**R66 SERVICE BULLETIN SB-41**

**SUBJECT:** Tail Rotor Blade Inspection and Replacement

**EFFECTIVITY:** P/N F029-1 tail rotor blade S/Ns 3099 and prior (F029-1 REV F and prior).

**SPECIAL TAIL ROTOR TIP PREFLIGHT INSPECTION**

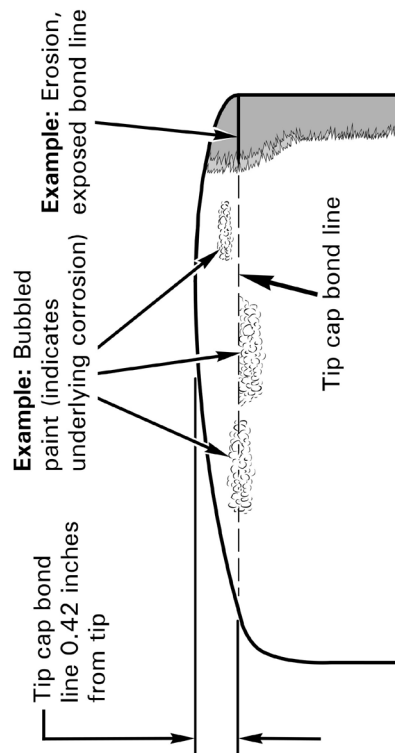
To be performed before the first flight of each day. May be performed by pilot or mechanic. Conduct visual inspection of tail rotor tip area. If bubbled paint or other evidence of corrosion is observed at or adjacent to tip cap bond line or if any portion of tip cap bond line is exposed, do not fly helicopter. Comply with latest revision of R66 SL-40 prior to further flight.
